DOCKETED	
Docket Number:	24-OPT-03
Project Title:	Soda Mountain Solar
TN #:	265867
Document Title:	Desert Tortoise Council Comments Soda Mtn Solar Project Scoping Comments to CEC 9-3-2025
Description:	Received by CEC staff via email before the 5pm deadline on September 3, 2025.
Filer:	Lorenzo Cano
Organization:	California Energy Commission
Submitter Role:	Energy Commission
Submission Date:	9/4/2025 9:47:00 AM
Docketed Date:	9/4/2025

RE: Environmental Scoping Comments for Preparation of a Draft Environmental Impact Report
for the Soda Mountain Solar Project (Docket No. 24-OPT-03)

Figure 1. Location and layout of Soda Mountain Solar Project.

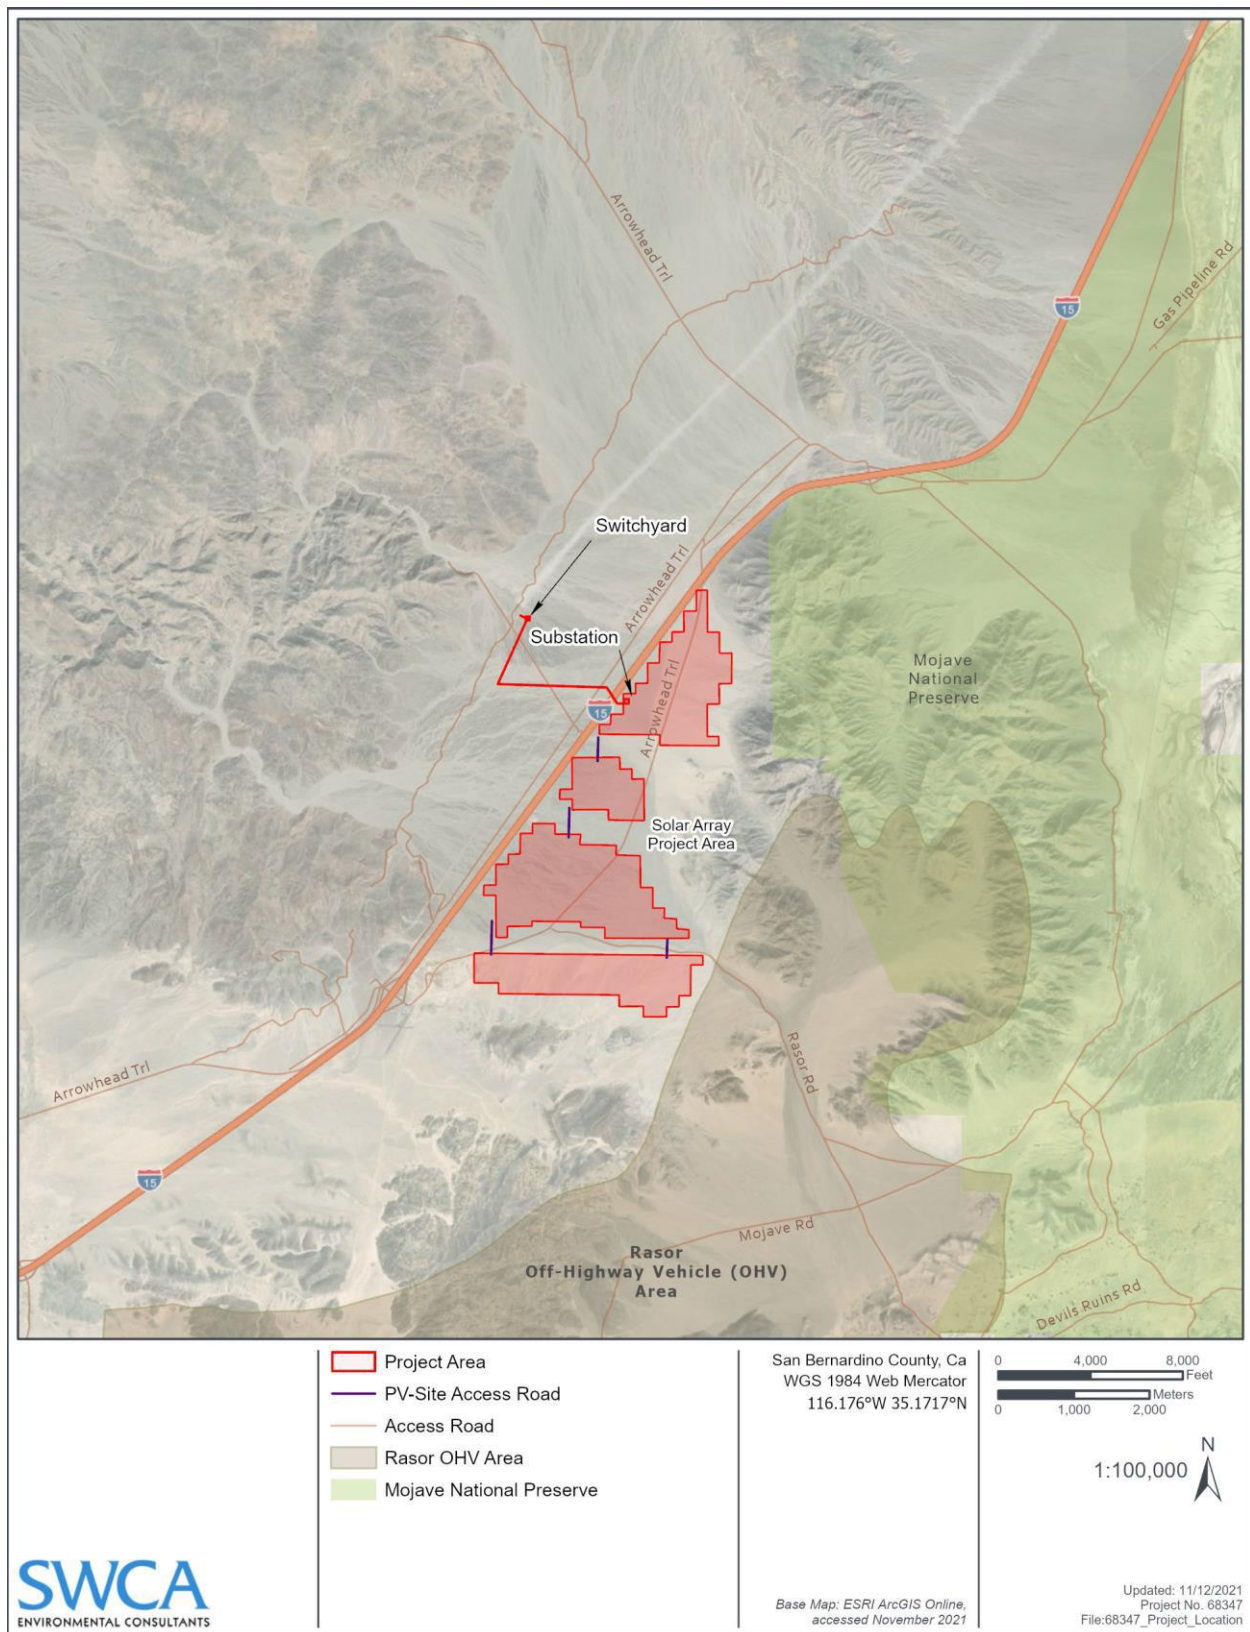
In comparing the acreage that would be impacted by the Proposed Project in the NOP (1,490 acres) and the Revised Project described by BLM (2,059 acres), the acreages obviously differ. Please explain this difference. **One way would be to provide a list of the acres impacted for each component of the solar facility (including access roads) and whether the impacts would persist throughout the construction and operation and maintenance of the project (= long-term permanent impacts) or be restored (= long-term temporary impacts).**
